**TOWN OF BAY HARBOR ISLANDS
DEVELOPMENT AND REVIEW COMMITTEE
AGENDA
October 14, 2021**

ITEM: Review and discussion of Site Plan Review Application by BH 103, LLC in order to construct a 35 unit Multi Family development to be located at 10270-90 East Bay Harbor Drive. Enclosed is a copy of the proposed site plans.

Subject: Site Development Plan Application – 2nd Revised Submittal
10270-90 East Bay Harbor Drive (35 DU)
Bay Harbor Islands Acct. No. SPR21-00013
MMPA Acct. No. 01-0702-1112

Site Development Plan Application – 2nd Submittal
10270-90 East Bay Harbor Drive Multifamily Residential Development (35 DU)
Development Review Committee – Comments on 9/20/21 Preliminary Revisions
September 23rd, 2021
Page 4

SHEET NO.: C-1

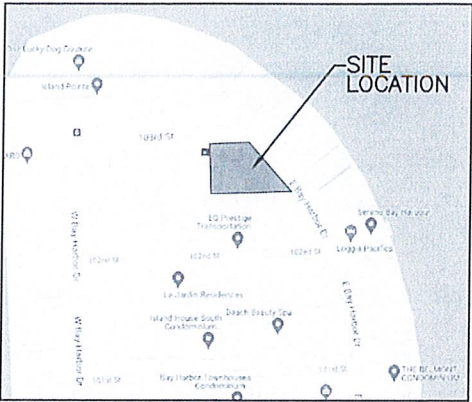
SHEET C-1- Please provide a detail for the oil/sand interceptor and drainage well. These are located under the "Loading" stall. For maintenance, this could be an issue and also depending on the weight of the loading vehicle this could affect the space.

SHEET C-1 - Please provide limits of milling and paving limits along 103rd Street and East Bay Harbor Drive. These areas would be damaged by the trucks coming in and out for construction. On sheets C-1 and C-2 we show milling and paving for the roadway area where 103 Street will be cut for the utility installation.

SHEET C-1- Please show turning radii in the sheet. Some of these look tight.
Turning radii are shown on sheet C-3.

The drainage well and interceptor details will be added during construction documents. On sheet C-1, the well and interceptor have been moved so they are no longer directly under the loading space.

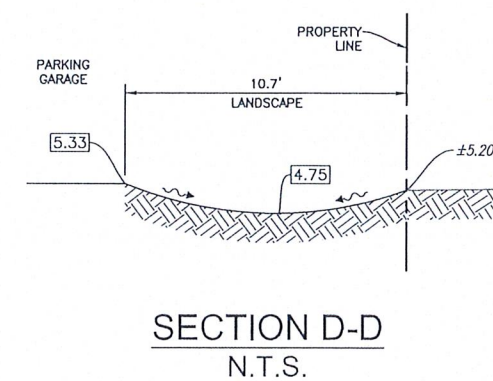
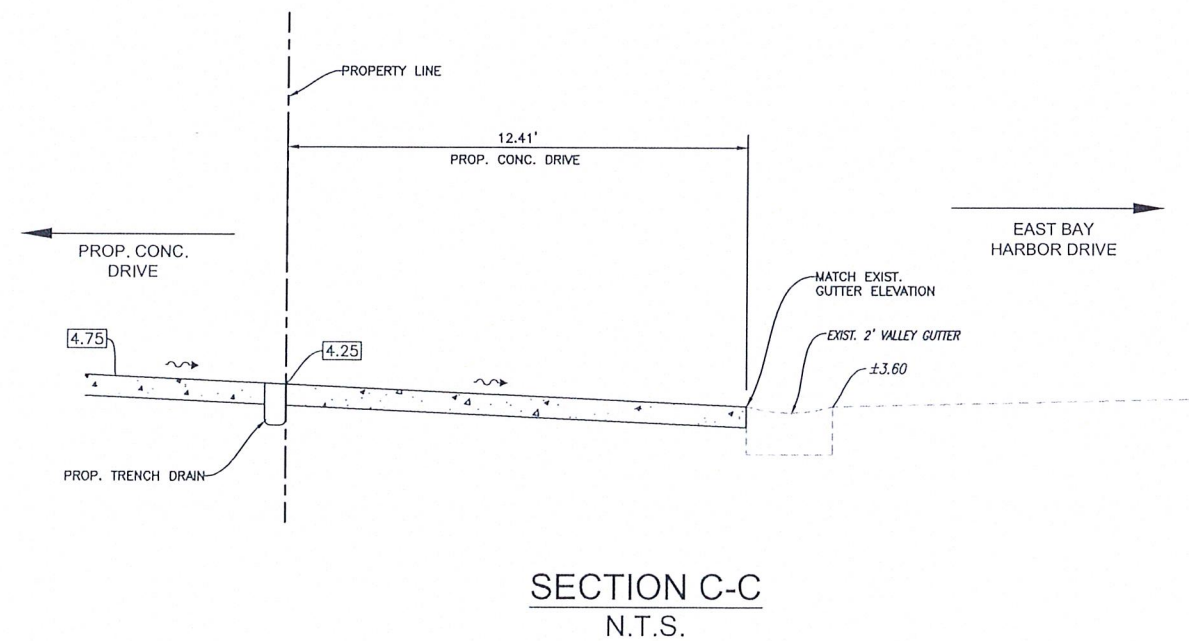
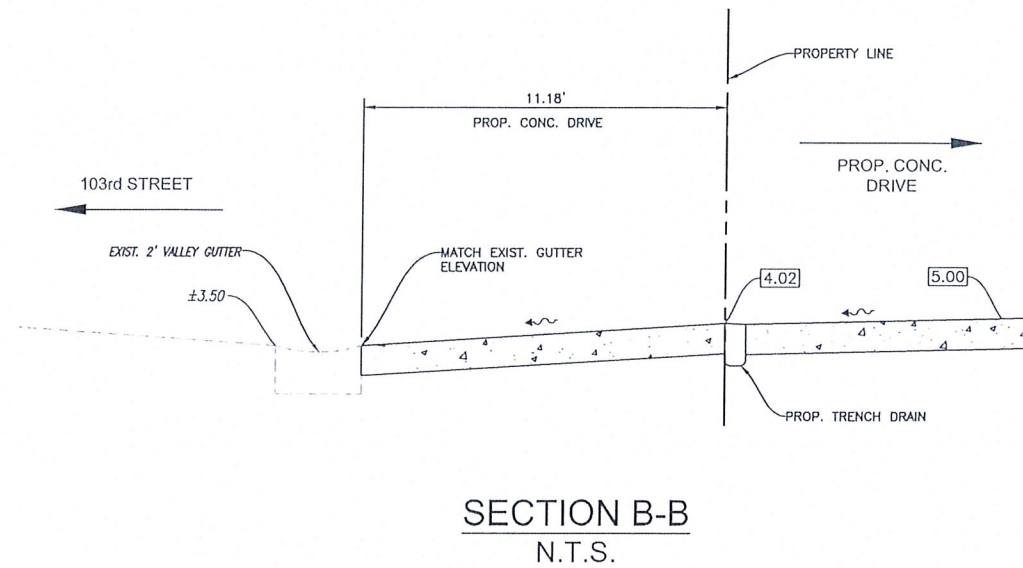
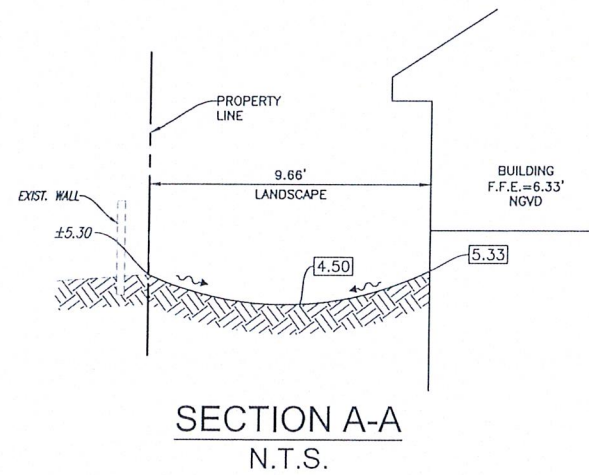
1. Provide cross section at the southern property line
 - a. Cross-section D-D has been added and is detailed on sheet C-4.
2. Provide Drainage calculations
 - a. Drainage calculations for the well have been provided.
3. Show how existing water services are connected to the existing water main in the R.O.W.
 - a. We no longer plan to use these 1" water services. The as-builts show a 6" WM connection is East Bay Harbor Drive for these existing services.
4. Show limits of milling / resurfacing on East Bay Harbor Drive (if applicable)
 - a. We are showing milling & resurfacing on 103 Street where the utility connections will be made. Right now, we don't see a need to mill and resurface East Bay Harbor Drive.

A301

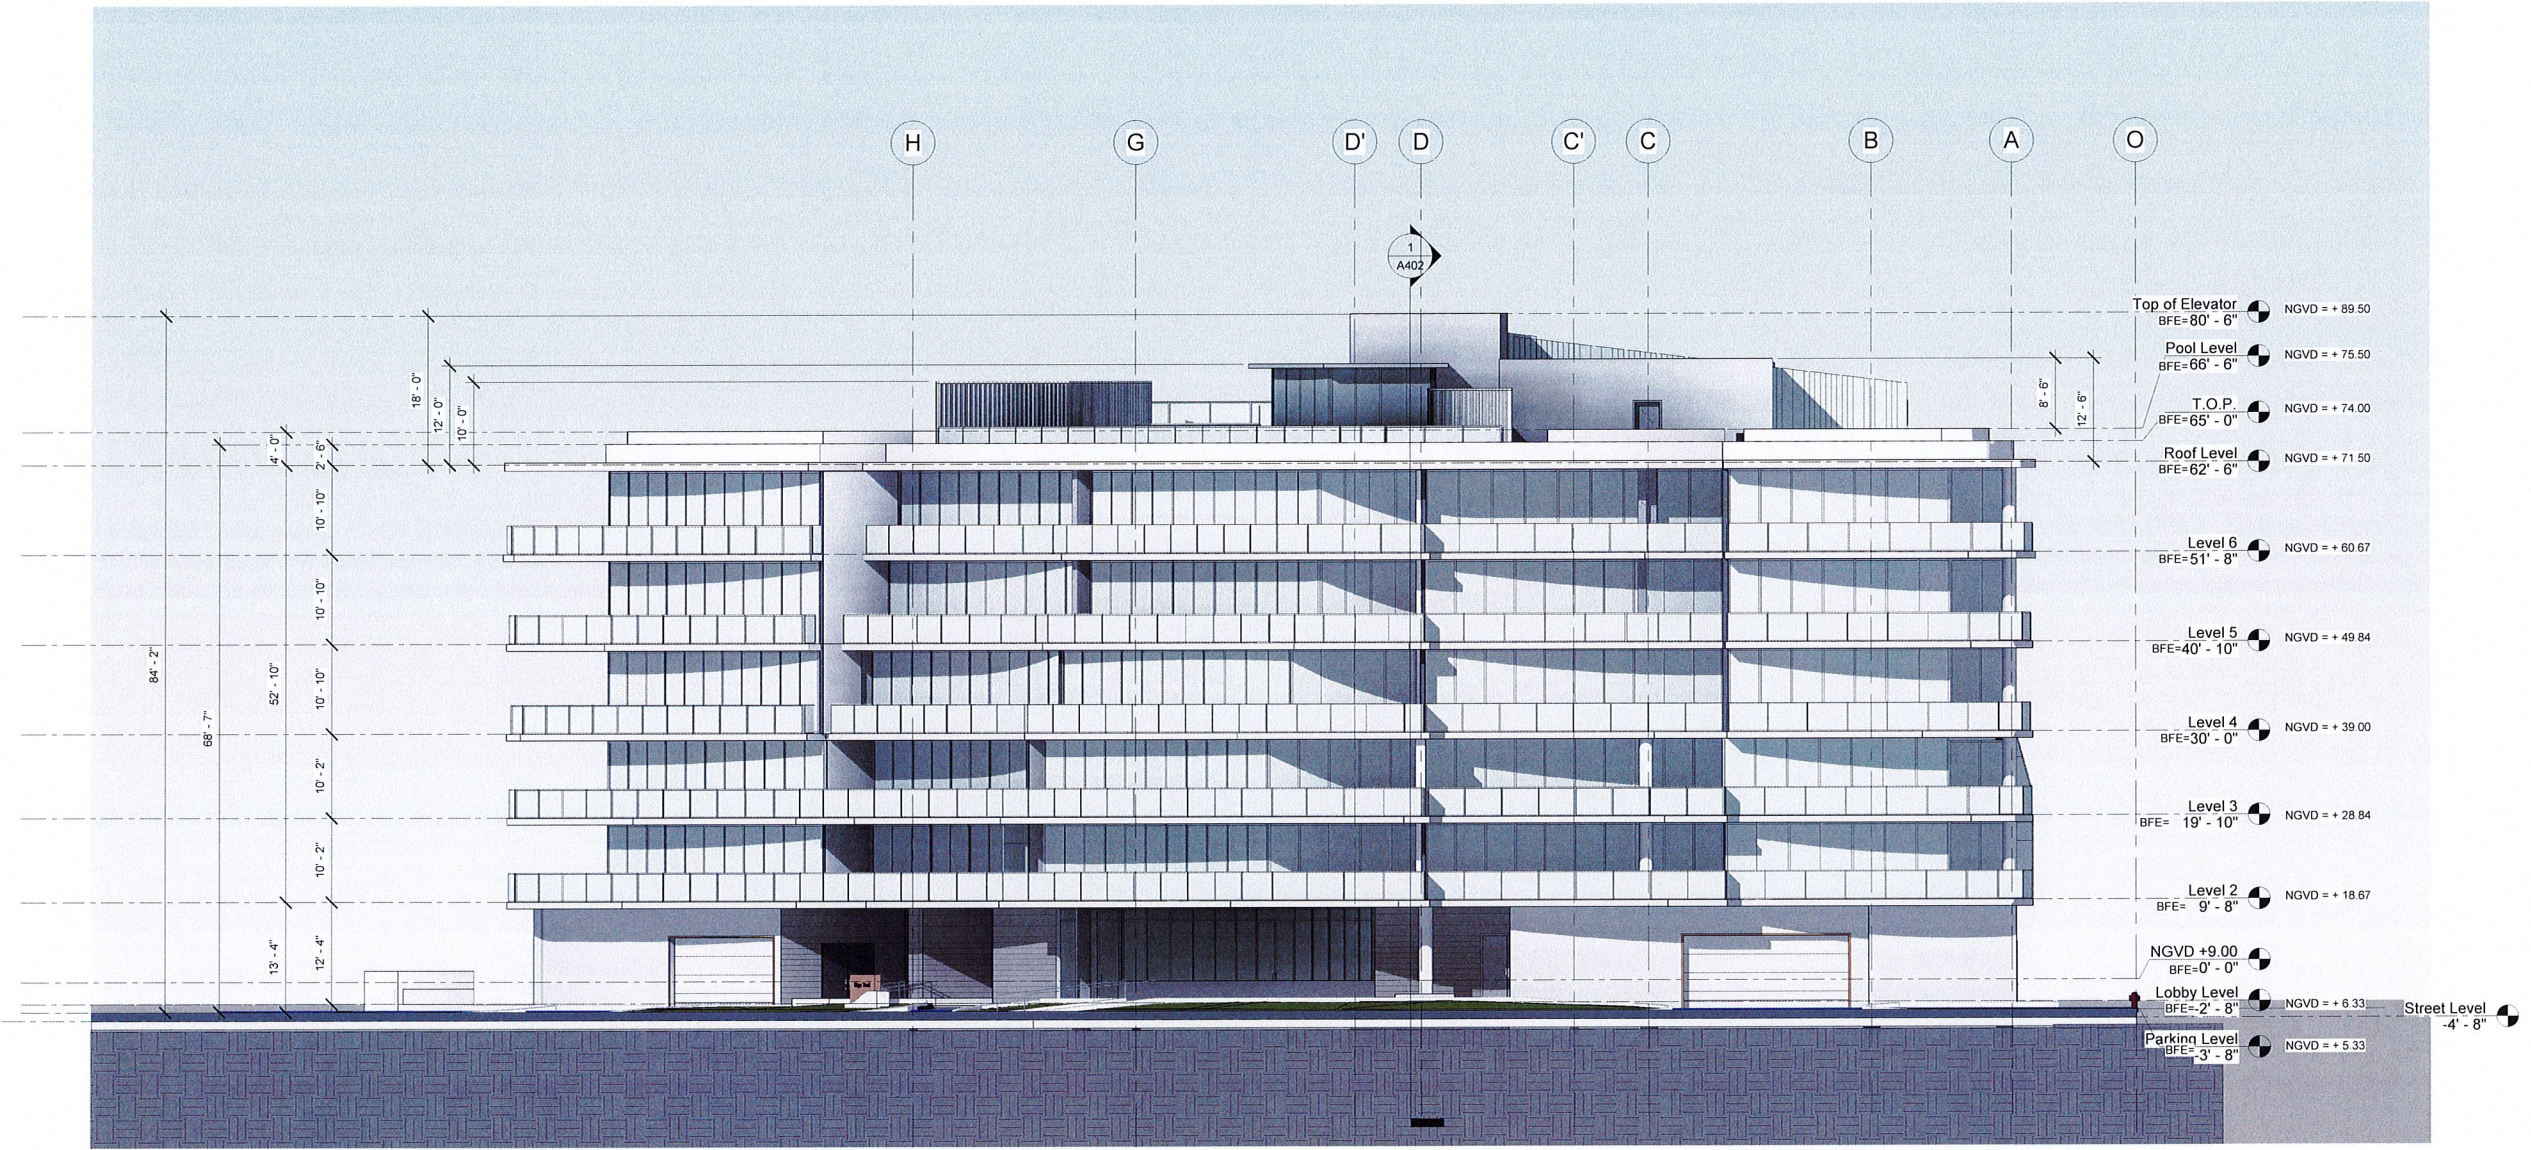
14. Page A301 – Building Hgt. – The site is currently located in FEMA FIRM Flood Zone AE-9.0 NGVD. FEMA is currently updating the FIRM map for MD County – adoption date unknown. The draft map is anticipated to change the BFE in this location to AE-7.0 NAVD (8.67'+/- NGVD). Bldg. height allowance in the Town is measured from existing FEMA BFE (65' above 9.0' NGVD). The plans are drawn to comply with an elevation that does not exist as yet – and may not for a while. State law prohibits the Town from using other than the adopted FEMA map elevations. The new proposed FEMA BFE is lower than the existing BFE. The proposed bldg. height appears to be lower than the maximum allowed. The rooftop features appear to meet the allowable bldg. hgt. limits / setbacks, except the pool / pool deck mentioned above. FYI – the Town cannot approve a plan based on a future FEMA map.
[Elevations have been updated to comply with BFE = 0'-0" = +9.0' NGVD](#)

A401

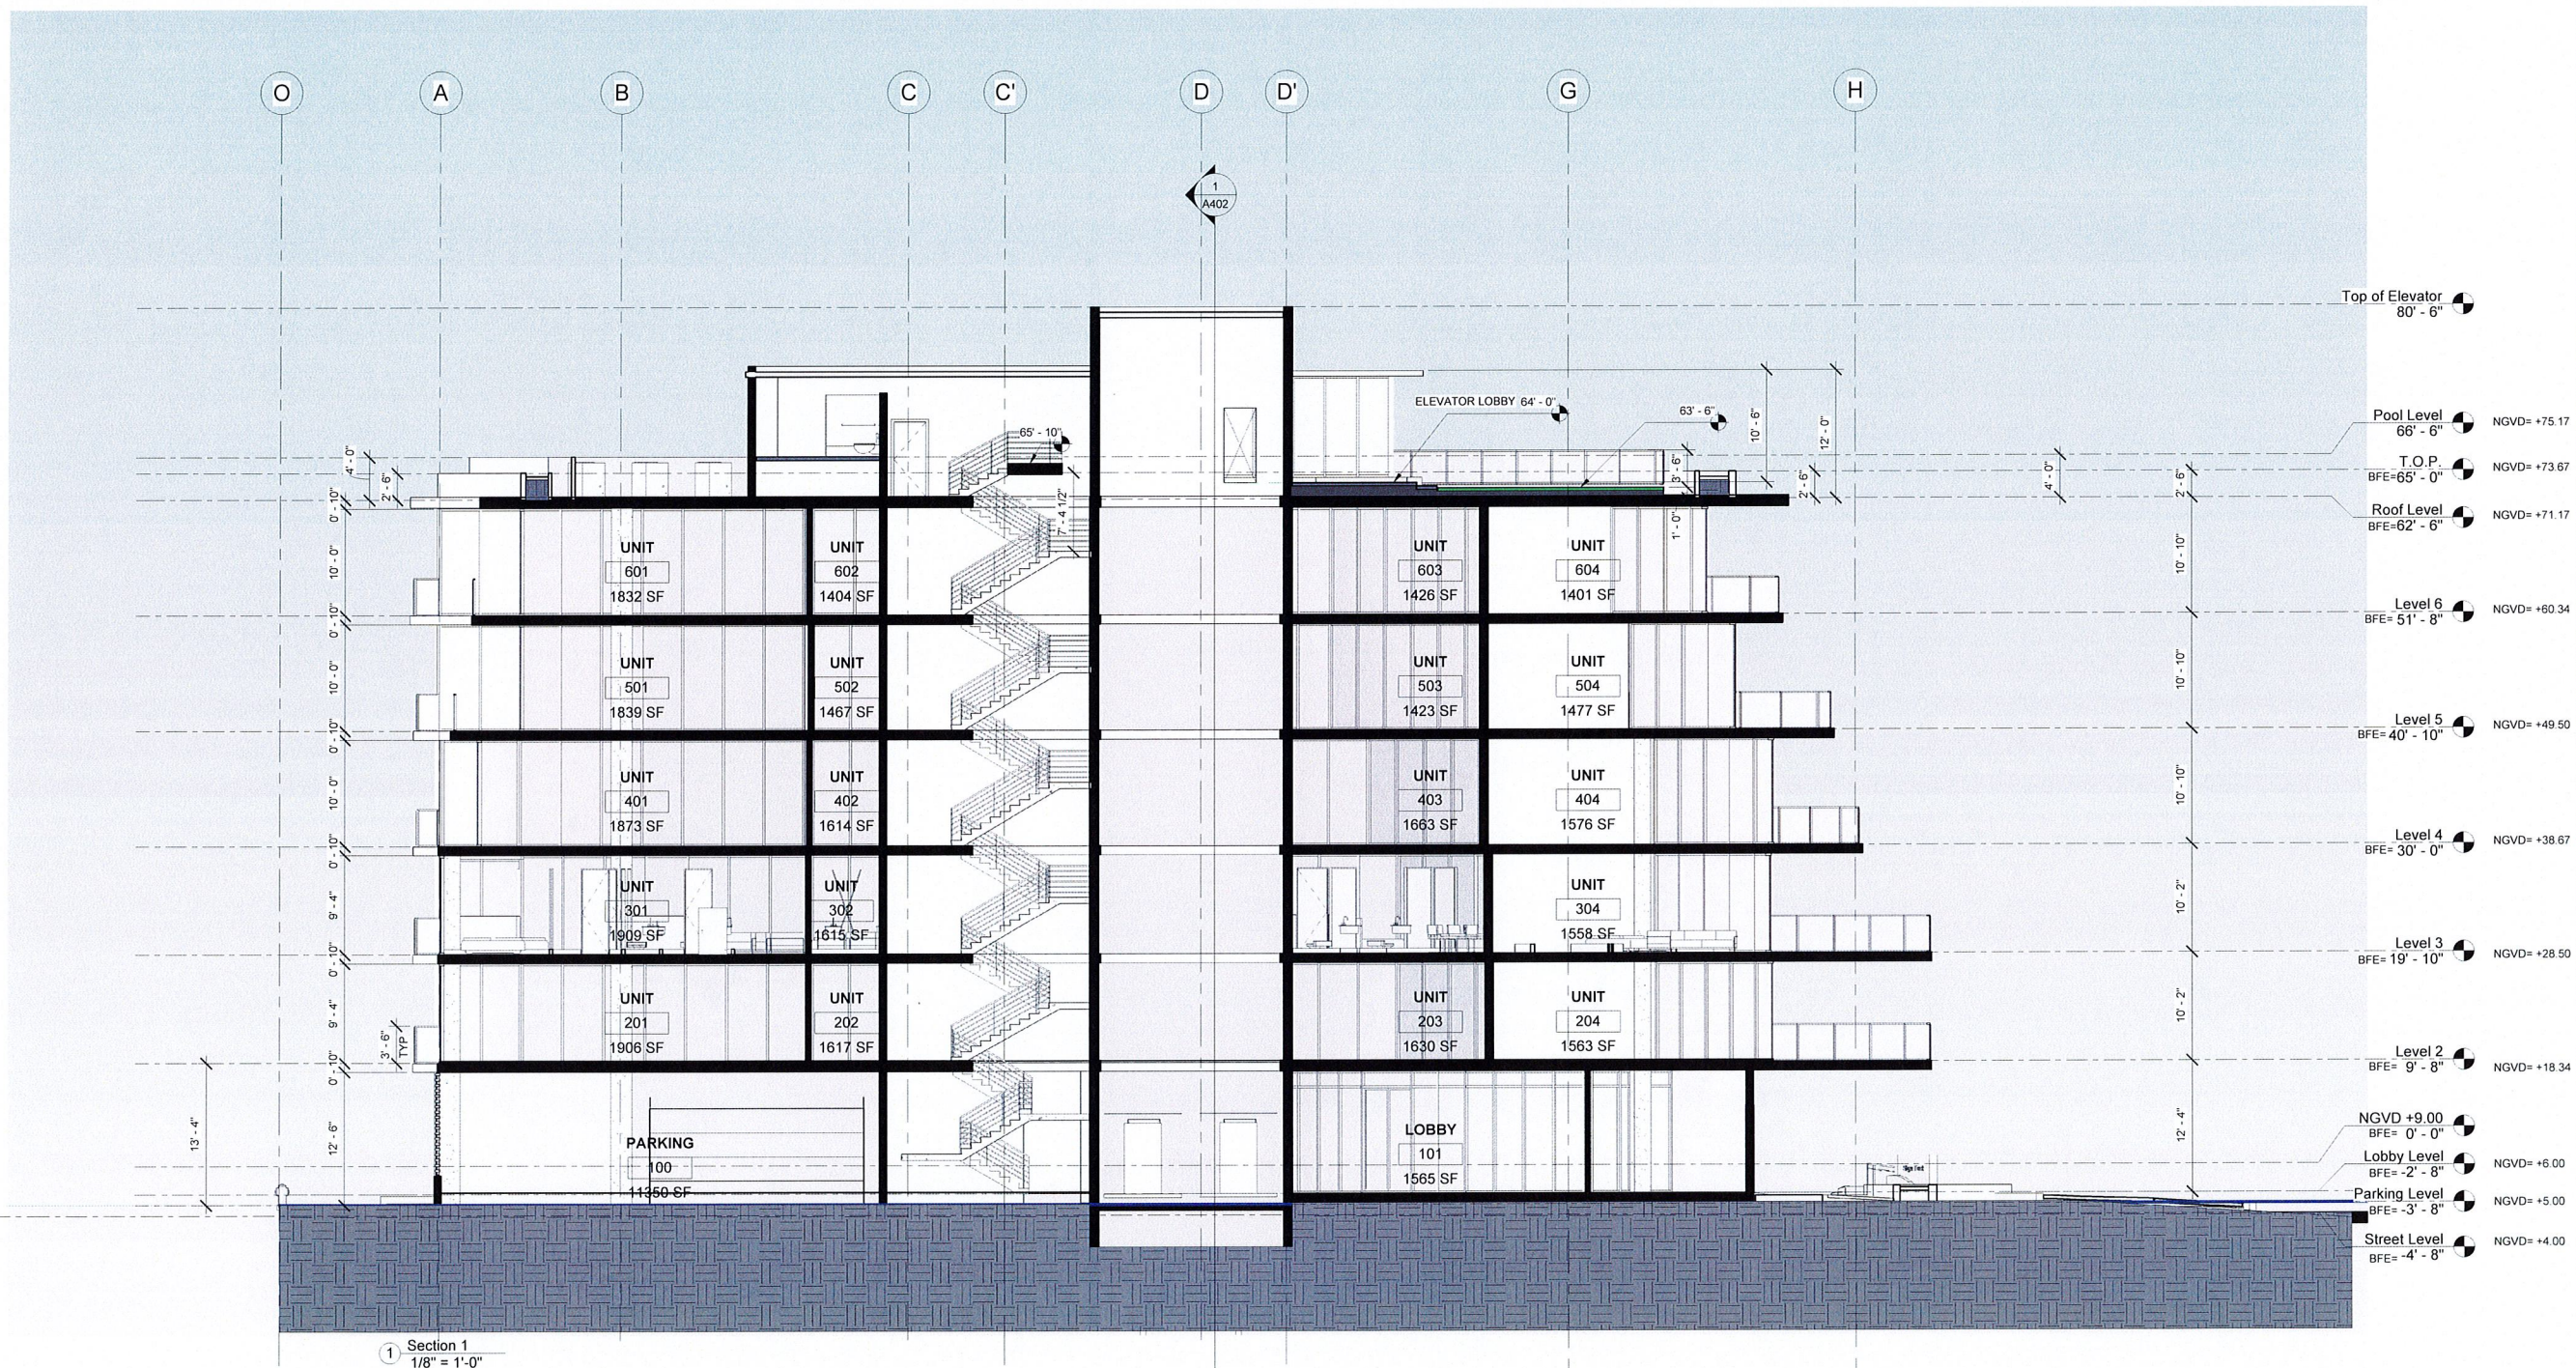
16. Page A304 – the bldg. height elevations are shown as "NGTV" – not "NGVD" – correct typo.
[Typo corrected. Thank you](#)
17. Pages A401 & A402 – Sec. 23-11(B2)(9) of the Code requires at least 9' between floor slabs. You state in the response letter the distance is 9'-4" but the plans do not show that – the measurement marks are shown from the top of one slab to the top of the next slab – not top of one slab to bottom of next slab (9' min inside dimension). Please clarify.
[Internal dimension from top of slab to bottom of roof slab have been included in sections 2 and 3 to comply.](#)

Date	09-07-2021	Sheet No.	A1.02
Scale			
Project	2142

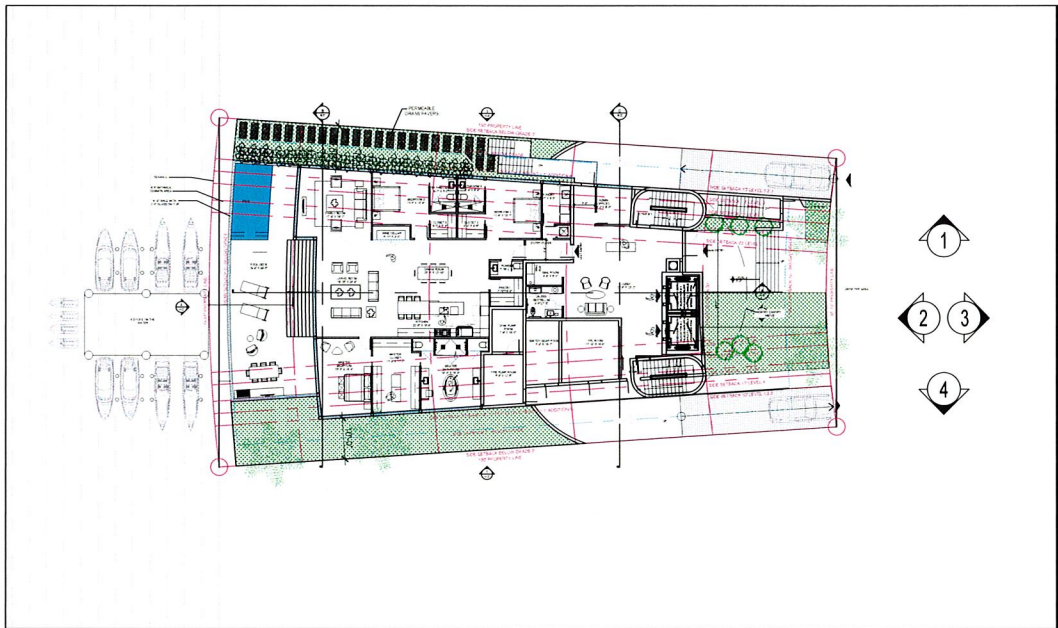
3. On Sheet A1.03 the Key Plan and several other plan sheets shows a proposed future boat docking facility. The survey shows an existing Code compliant dock at the site at present. The size and shape shown violates numerous Code allowances. The Town owns all of the water surrounding the islands per the State Chapter (water / land under the water). Per Code Sec. 23-12(6) no dock may extend more than 25' from a seawall into a waterway. If any portion of a dock extends more than 8' from the seawall the maximum width cannot exceed 4'. Remove the large dock from the plans as shown – you can show the existing / future dock parallel to the seawall.
